SERVICE BULLETIN

M-1077

1999 FLT FUEL TANK AND VOLTAGE REGULATOR HARNESS SET-UP

Figure 1. Fuel Tank Fastener Tightening Sequence

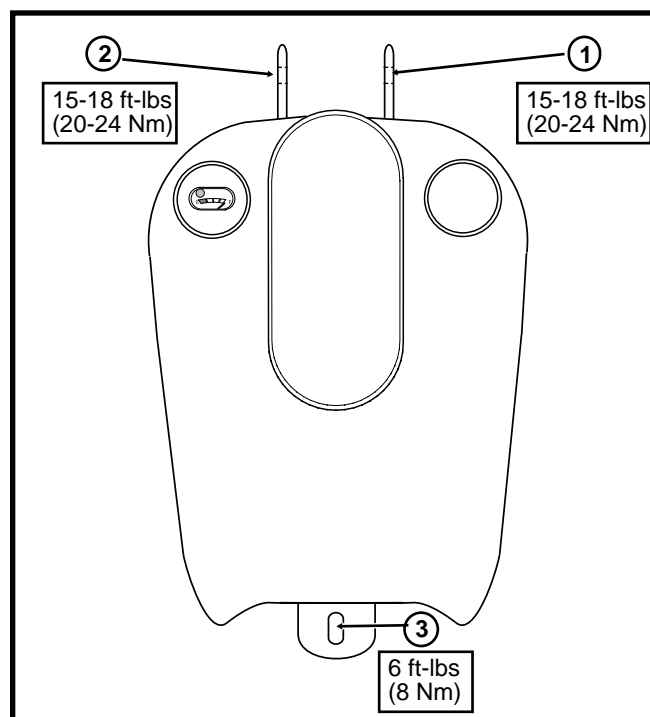
1. Remove seat. See SEAT, REMOVAL in Section 2 of current FLT Service Manual.
2. See Figure 1. Loosen console acorn nut (FLHR/CI) or allen head screws (all other FL models).
3. Loosen right front fuel tank fastener.
4. Loosen left front fuel tank fastener.
5. Loosen rear fuel tank tab fastener.
6. With tank aligned on frame, check right front tank mount to make sure it is straight (parallel to mounting tunnel). Straighten right tank mount as required.

The following tightening sequence, as listed below, must be followed to ensure proper fuel tank to frame alignment. An assistant may be required to hold the tank in alignment with the frame while tightening the fasteners.

7. Tighten **right front** fastener to 15-18 ft-lbs (20-24 Nm).
8. Tighten **left front** fastener to 15-18 ft-lbs (20-24 Nm).
9. Tighten **rear** tab fastener to 6 ft-lbs (8 Nm).
10. Position console on fuel tank for best appearance and tighten acorn nut to 80-100 **in-lbs** (9-11 Nm) (FLHR/CI) or allen head screws (all other FL models).
11. Install seat. See SEAT, INSTALLATION in Section 2 of current FLT Service Manual.

Figure 2. Voltage Regulator Cable Routing

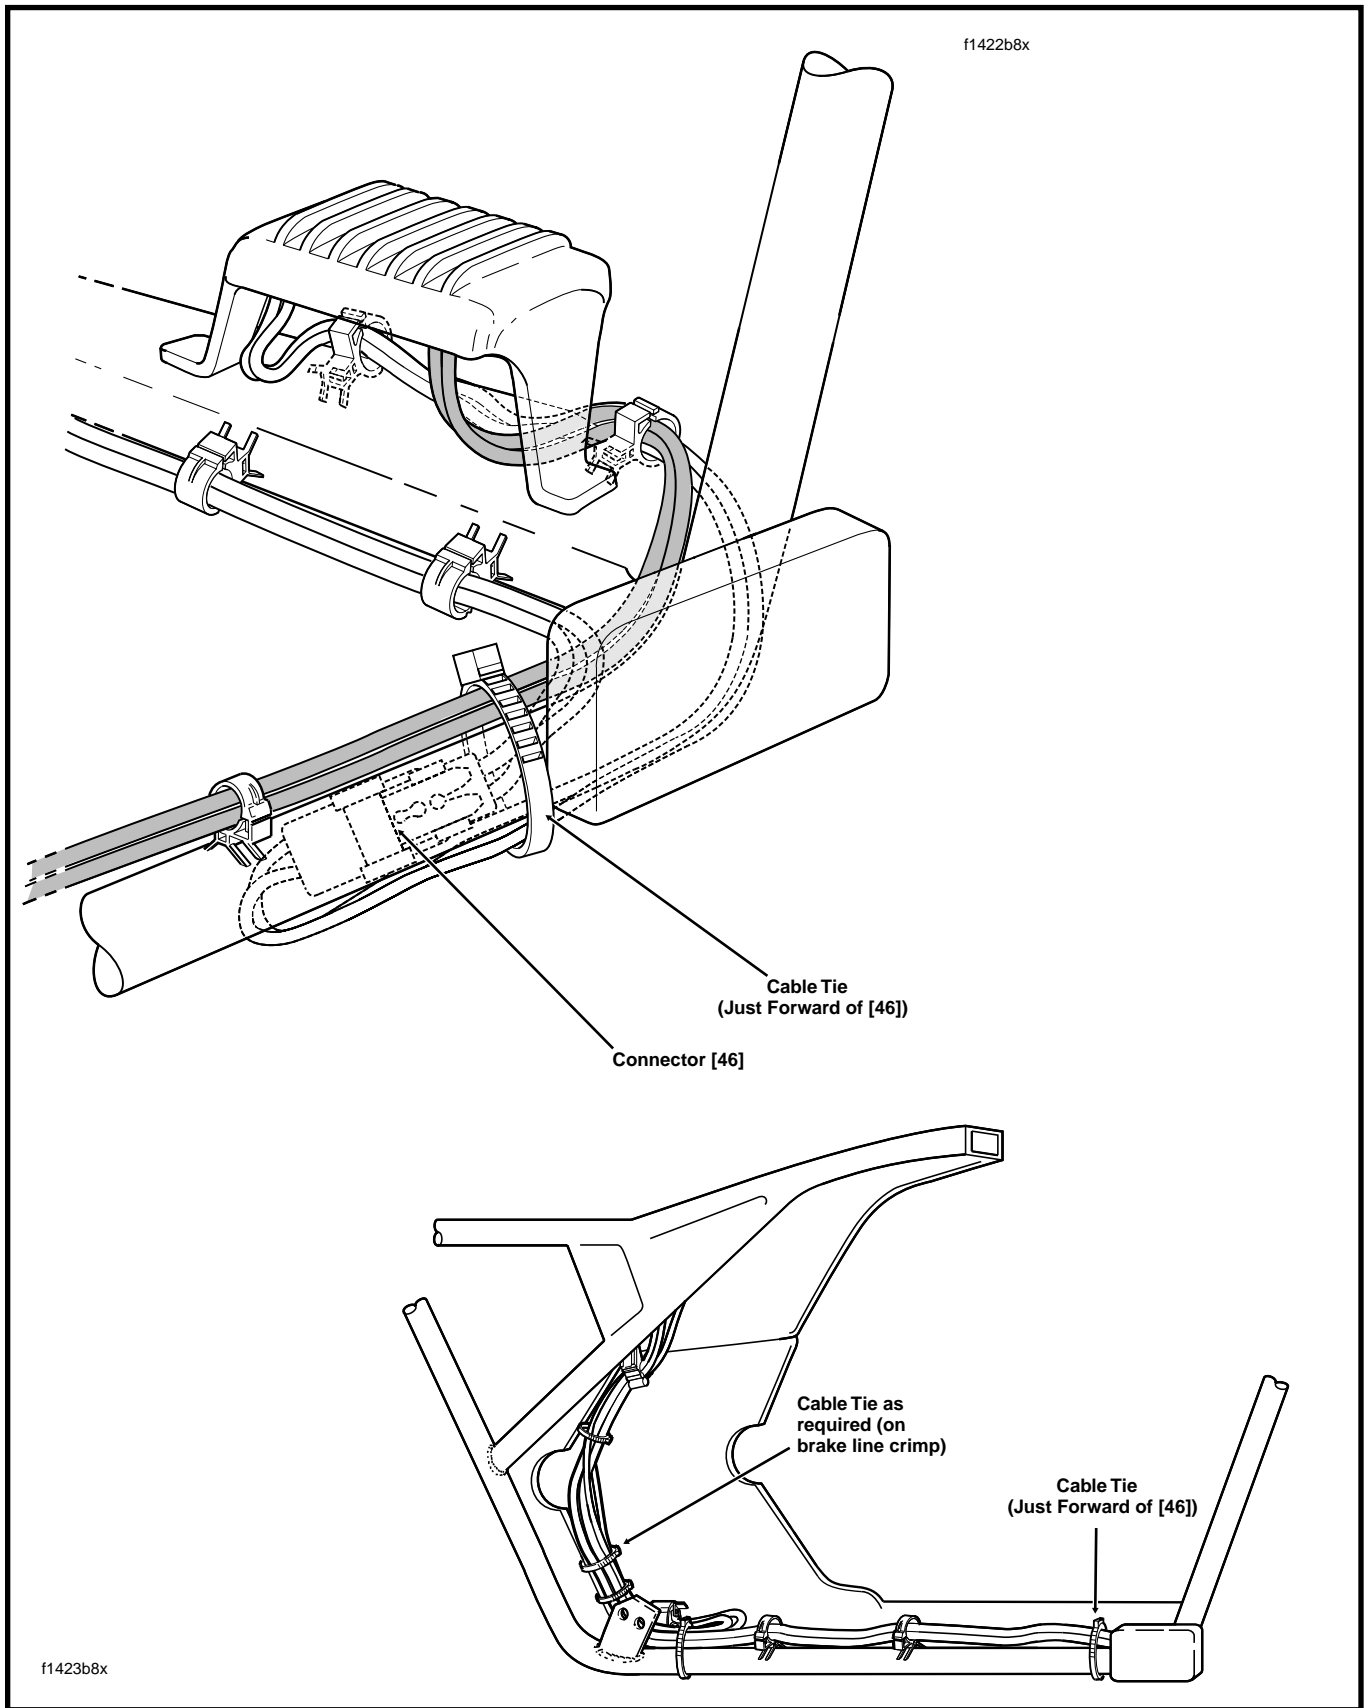
1. See Figure 2. Inspect the voltage regulator wiring harness routing forward of connector [46]. Make sure wiring harness is tucked up close to frame tube to prevent possible damage from road debris or powertrain movement. Inspect voltage regulator wiring harness routing behind connector [46]. There is a machined surface on the bottom of the crankcase under the cam cover just to the rear of the connector. Make sure sufficient clearance exists between sharp edge of machined surface and voltage regulator wires. Cable tie top wires (by machined edge) and four lower wires forward of connector to frame tube as shown in upper illustration of Figure 2.

2. Inspect voltage regulator wiring harness routing just behind oil dipstick cover. Make sure enough clearance exists between voltage regulator wires and rear oil dipstick cover bottom socket head screw. Make sure wires are not between brake line and oil dipstick cover screw. Move wires behind brake line and cable tie wires to crimp in brake line (just under brake line clip) as required to provide adequate clearance. Do not overtighten cable tie on brake line.

Insufficient clearance between voltage regulator wires and powertrain will result in wire insulation being worn away over time and electrical problems with motorcycle. Cable tie wires to frame tube as required to provide for adequate clearance. Failure to comply will result in equipment damage.

Figure 3. Electrical Connections - Upper Frame Cross Member (Under Seat)

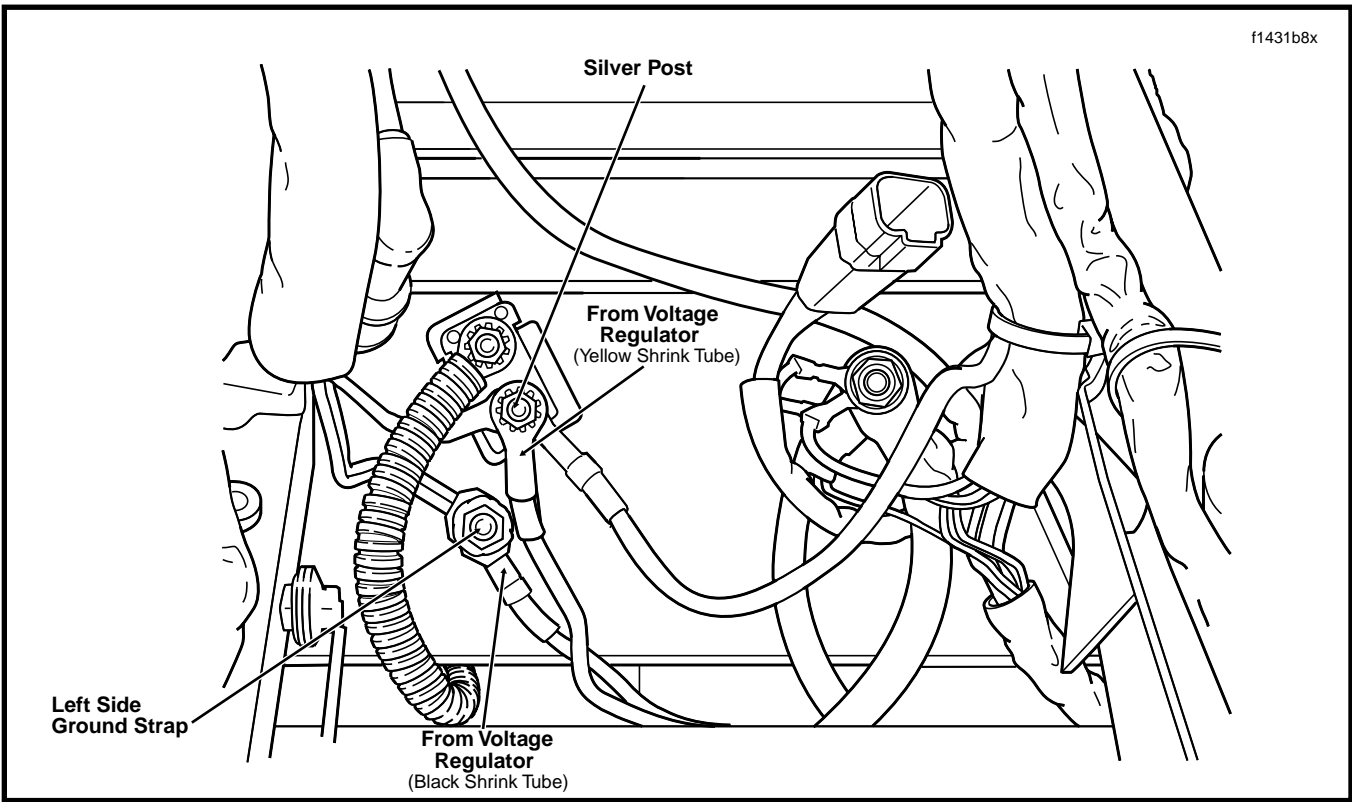
- *Yellow heat shrink tube wire secures voltage regulator wire to 40 amp main circuit breaker (silver post).*
 - *Black heat shrink tube wire secures voltage regulator wire to left side ground post.*
5. See Figure 3. Check both nuts that secure wires from voltage regulator to 40 amp main circuit breaker and left side ground post for proper tightness. Tighten to 20-30 **in-lbs** (2.3-3.4 Nm) as required.
 6. Install seat. See SEAT, INSTALLATION in Section 2 of current FLT Service Manual.
